SPECIFICATION REVISIONS  
REVISION TO STANDARD SPECIFICATIONS

PROPOSAL TO STANDARDS COMMITTEE

REVISION TO STANDARD SPECIFICATIONS  
SECTION 725 - SLIP LINING OF EXISTING PIPE

723-CCSP-01 THREE-SIDED CONCRETE CULVERT SCOUR PROTECTION

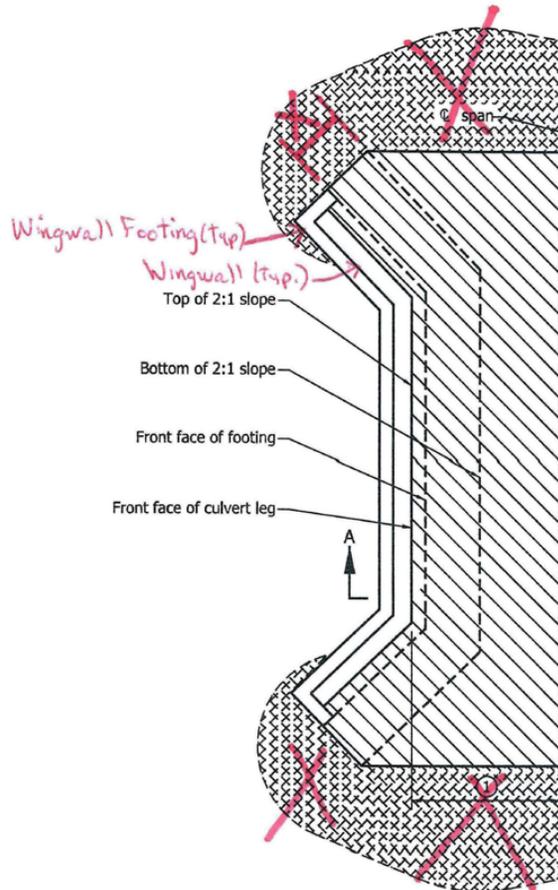
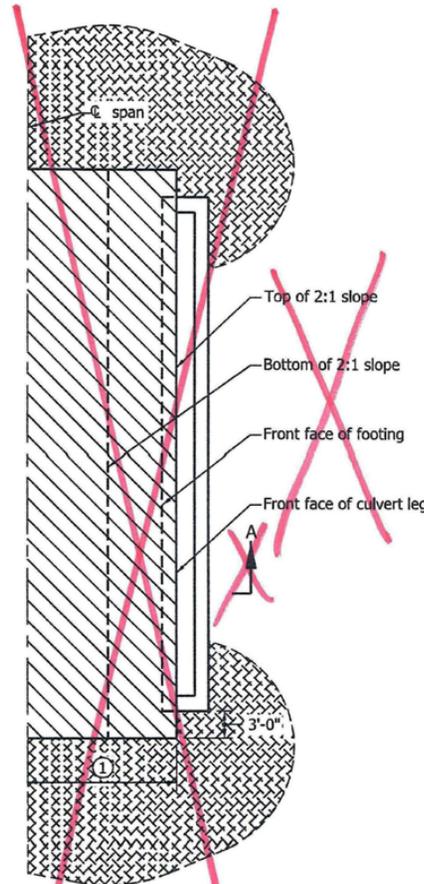
Delete the projecting option as shown in the attached Standard Drawings.

INDIANA DEPARTMENT OF TRANSPORTATION									
RAILING AND MOMENT SLAB AT MSE WALL SEPTEMBER 2009									
STANDARD DRAWING NO. E 706-BRRW-10

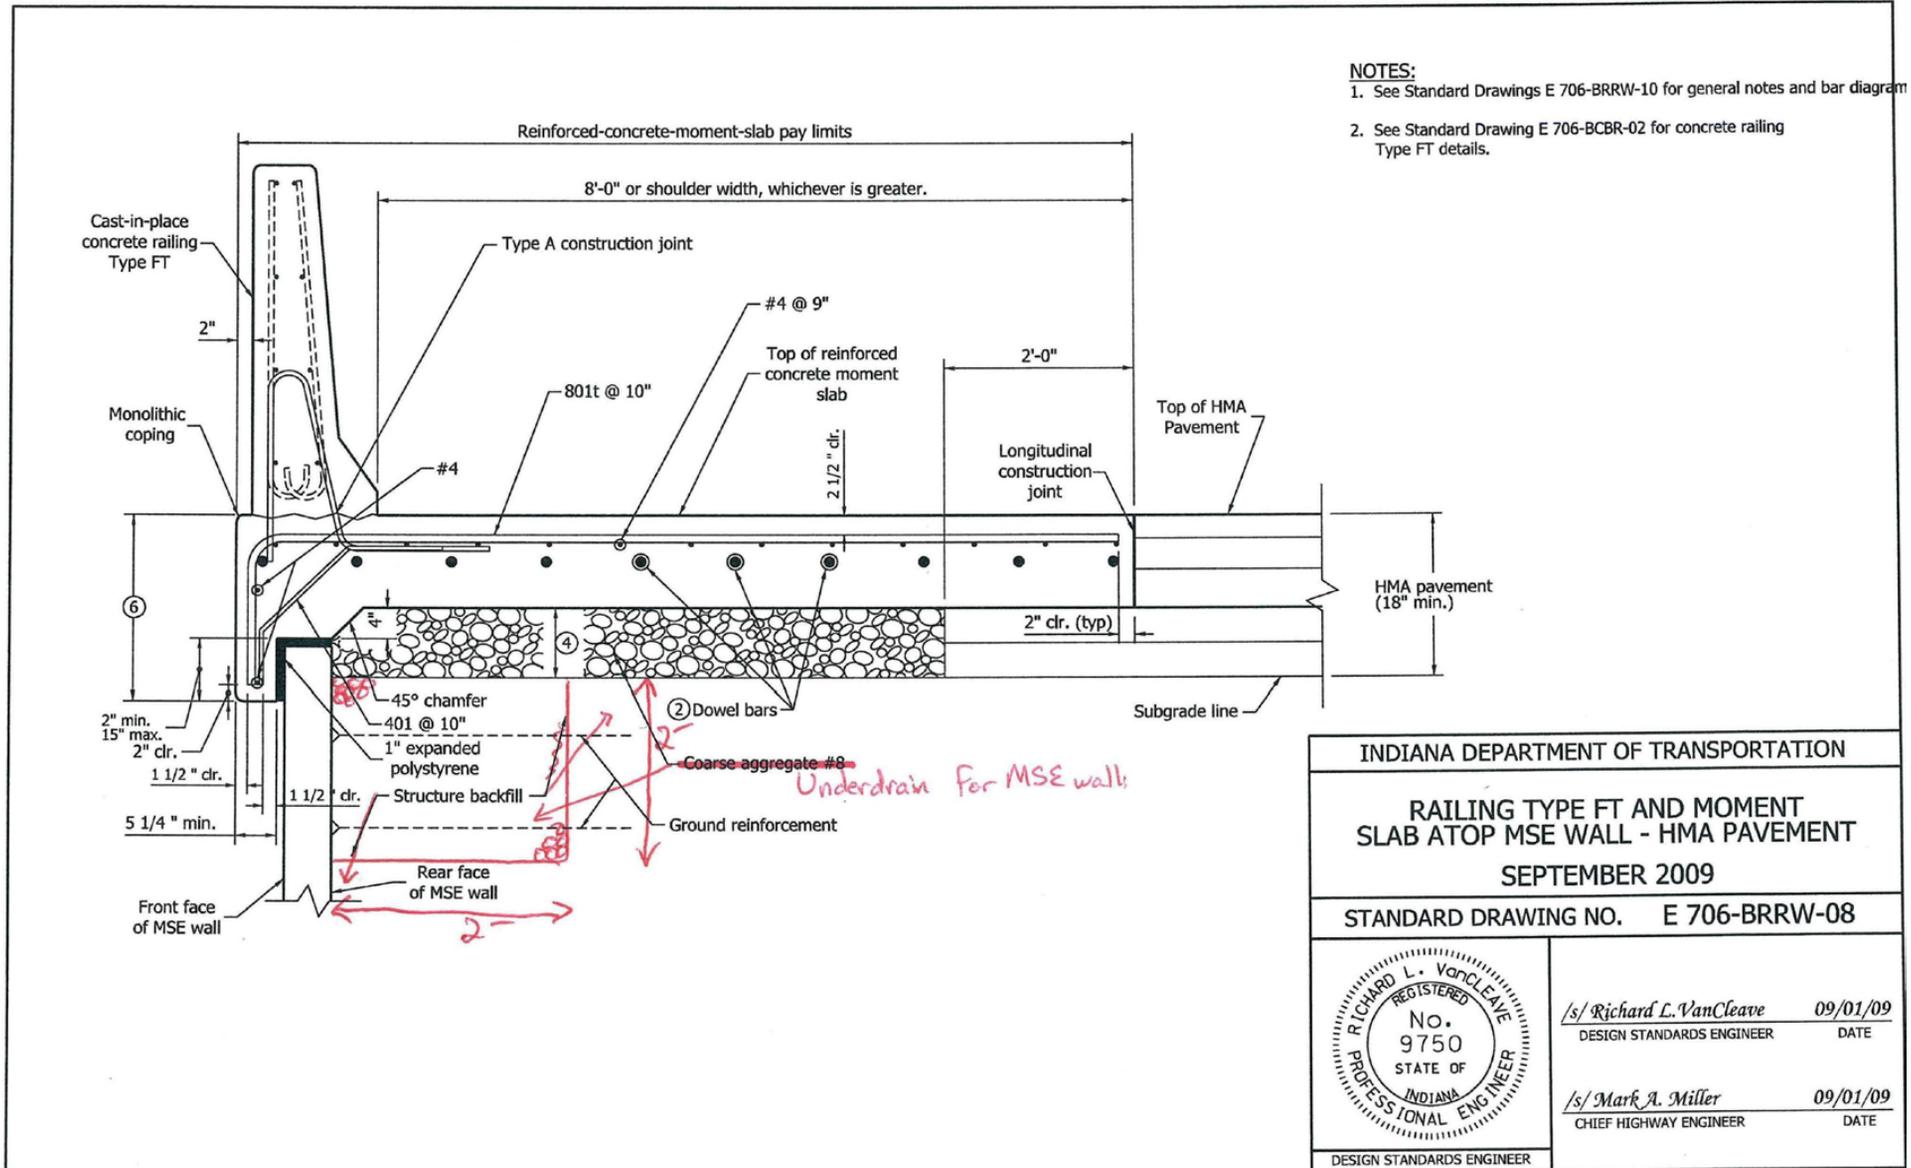
- ③ The coping by be precast or cast in place. See Standard Drawing E 731-BRRW-01 for coping details.
- ④ The thickness of the ~~coarse aggregate No. 8~~ <sup>Underdrain For MSE wall</sup> shall be equal to the combined thicknesses of the first two lifts of HMA, but not less than 6 in.

REVISION TO 503-CCPJ-08 LONGITUDINAL CONSTRUCTION JOINT

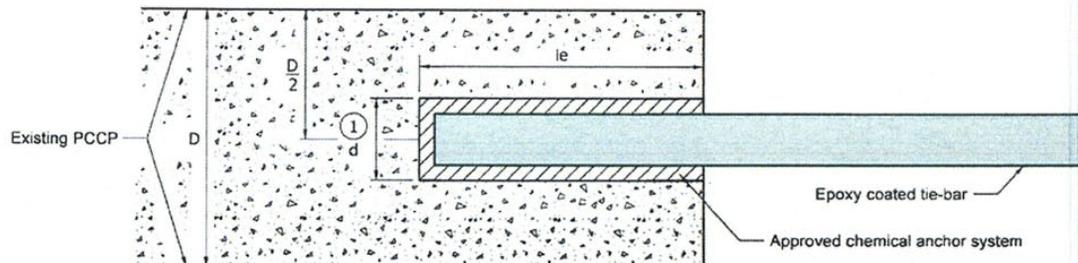
Standard Drawing E 503-CCPJ-02 - Revise tie bar sizes.  
Standard Drawing E 503-CCPJ-08 - Revise retrofit tie bar sizes.  
Standard Drawing E 506-CCPP-01 - Revise retrofit tie bar spacing, correct references, and make editorial revisions.

PAVEMENT THICKNESS, D	LONGITUDINAL CONSTRUCTION JOINT <i>Retrofit</i> Tie-bars at 3'-0 c/c	
	TIE-BAR SIZE	MIN. LENGTH OF EMBEDMENT, $l_e$
Less than 9" <i>or equal to</i>	#5	1'-0"
<del>9" to 12"</del>	<del>#7</del>	<del>1'-3"</del>
Greater than <del>12"</del> <i>9"</i>	<del>#8</del> <i>#6</i>	<del>1'-6"</del> <i>1'-0"</i>

PROPOSED NEW STANDARD DRAWING 709-SSBP-01 SURFACE SEAL IN BRIDGE-STEEL-PAINTING PROJECT (DRAFT)

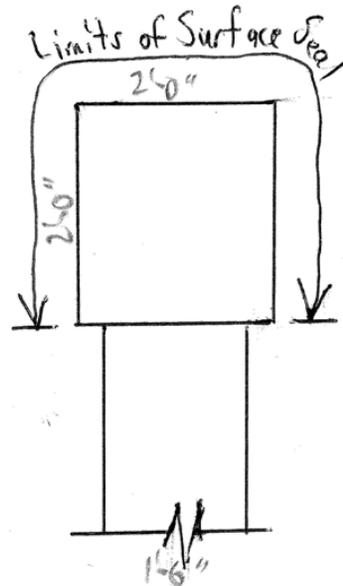
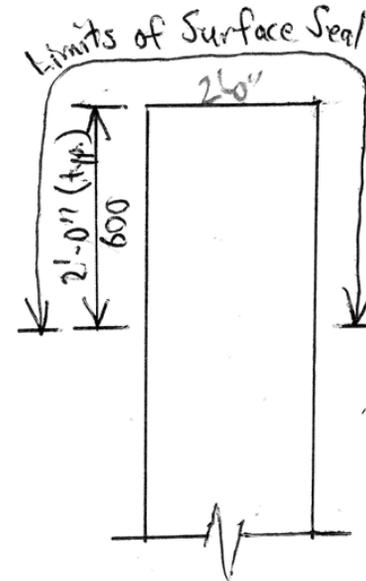
*Concrete surfaces <sup>shown on the plans for</sup> on existing bridges with structural steel to be repainted shall be prepared and sealed with epoxy penetrating sealer in accordance with 709.05(b). The portions of abutments and bents to be sealed shall include the vertical surfaces above the tops of such abutments or bents and the tops and the sides of the caps. For portions of piers or bents which do not have definite demarcations for caps, the sealer shall be extended 24 in. (600 mm) below the tops on all accessible sides.*

DELETED PORTION TO NEW STD DWG 709-SSBP-01
